P-18091-1

S5787

ISSUE-2

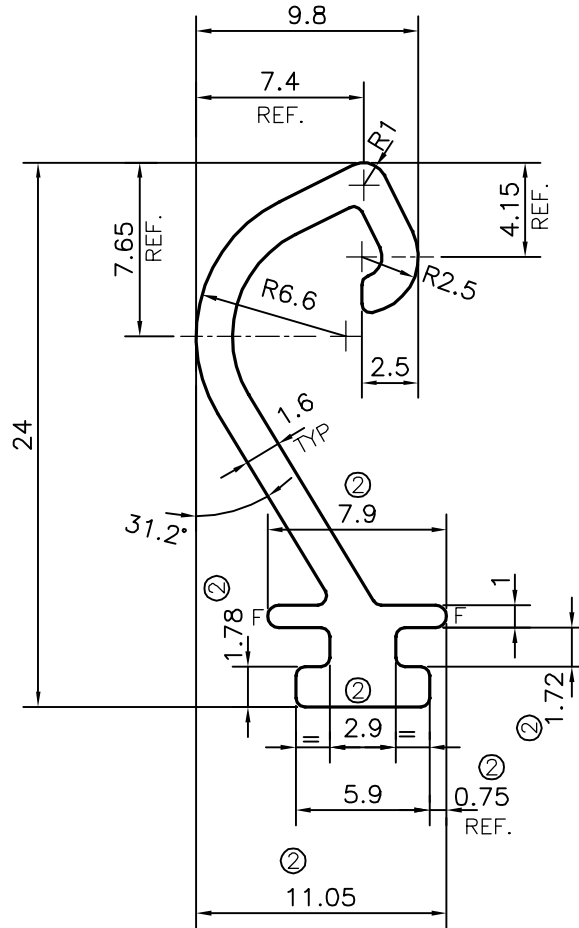
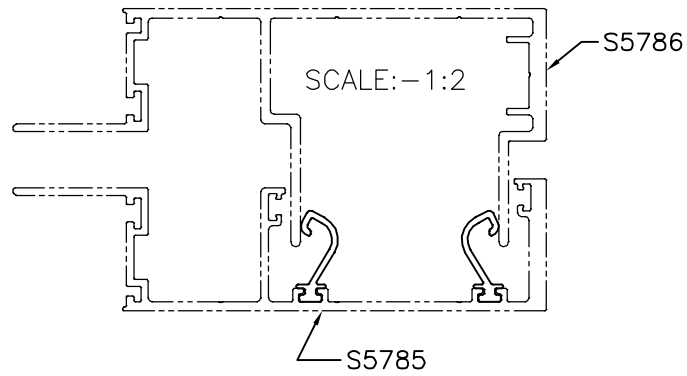
DIMENSION CHANGED FROM 10.3 mm TO 11.05 mm & FROM 5.4 TO 7.9, FROM 2.5 TO 2.9
 DIMENSION CHANGED FROM 0.25REF.TO 0.75REF.mm & FROM 1.75 TO 1.72 mm
 THICKNESS CHANGED FROM 1.75 TO 1.78 mm

WEIGHT ALSO CHANGED FROM 0.184 TO 0.193 kg/m
